4 May 2012

SUBJECT:

**SUBMISSION - HOMEBUSH BAY BRIDGE – PROJECT
APPLICATION MP 10_0192 Proposed public transport and
pedestrian / cycleway bridge across Homebush Bay
(Wentworth Point to Rhodes)**

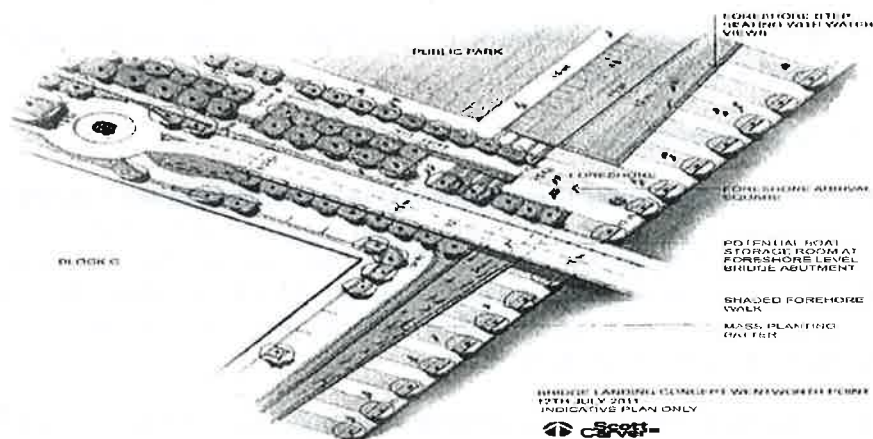
Comment: Wentworth Point Bridge Landing - Cycle Connections

The benefits of the grade-separated landing/approach at the Wentworth Point end of the bridge are noted (i.e. safety). However there appears to be extremely poor connection, particularly for cyclists, between the Wentworth Point side Promenade and the Wentworth Point bridge approach. It is anticipated that this will be a strong desire line for both recreational and commuter cyclists. The

cycling connections between bridge approach and promenade need to be improved to both the north (via replacement of steps with a ramp, or via an addition of a ramp) and south (via a ramp through the "mass planting batter") of the bridge. These recommended improvements will also significantly improve connectivity and accessibility for people with prams, and people in wheelchairs.

It is essential that the space under the bridge on the Wentworth Point side be appropriately illuminated at night time, as this Promenade cycle/pedestrian is likely to be used by commuter cyclists.
